Subject: FRONT BRAKES SQUEAK WHEN APPLYING BRAKES	Bulletin No: 04-001/08
	Last Issued: 1/16/2008

2007-2008 CX-7

2007-2008 CX-9

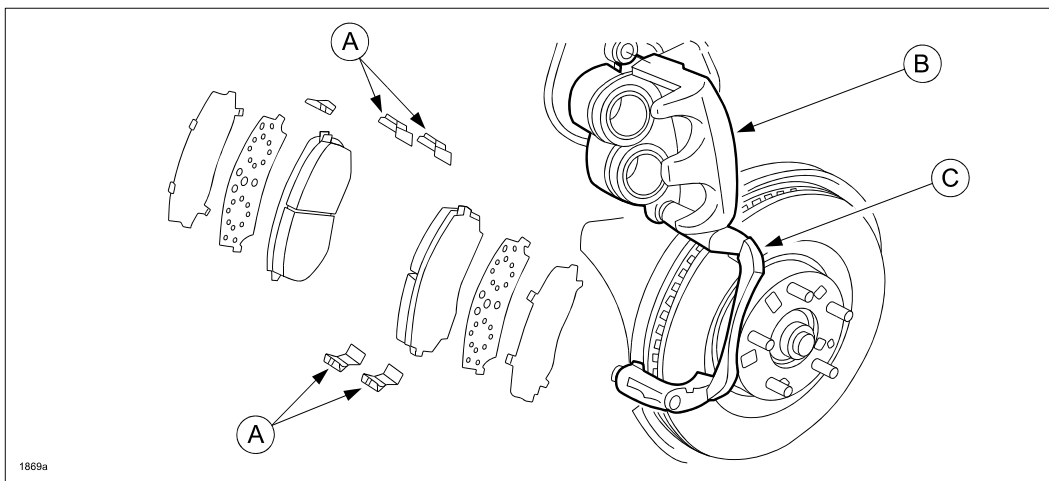
After parking in cold temperatures accompanied by a humid climate, some vehicles may exhibit a squeak from the front brakes during initial braking. This noise is caused due to deterioration of grease between the front disc pads, shims and the brake caliper.

When you encounter a customer complaint, replace the guide plates (A) with service parts, then apply white grease (provided with guide plates) to the location indicated on the caliper (B) and mounting support (C) according to the following procedure.

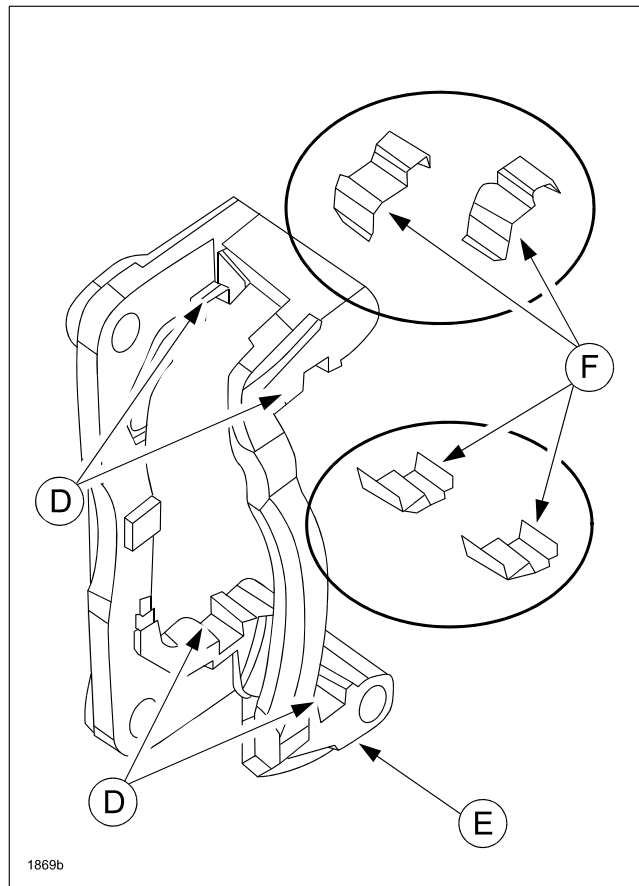
3. Clean the guide plate seating area (D) using brake parts cleaner or equivalent.

4. Peel off the backing sheet of the double-sided tape on the guide plate (F), then install the guide plate in the mounting support (E).

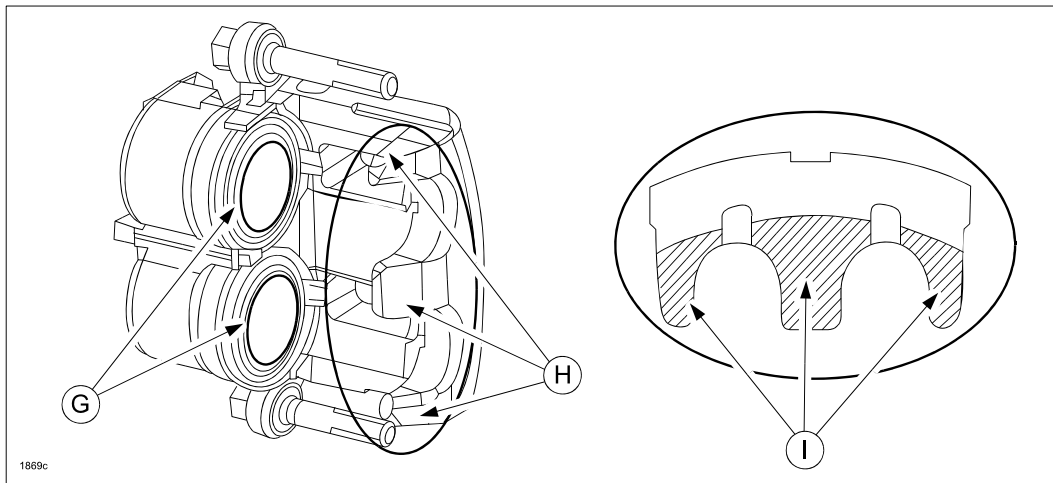
5. Clean the ends of the caliper pistons (G) and the caliper body (H, I) using brake parts cleaner or equivalent. Remove all shims from the disc pads and clean off black grease.

6. Lightly and evenly apply white grease (provided with guide plates) to the following:
 - End of brake caliper pistons (G).
 - Brake caliper body (I).
 - Pad-to-shim surface and between the shims (all shims).
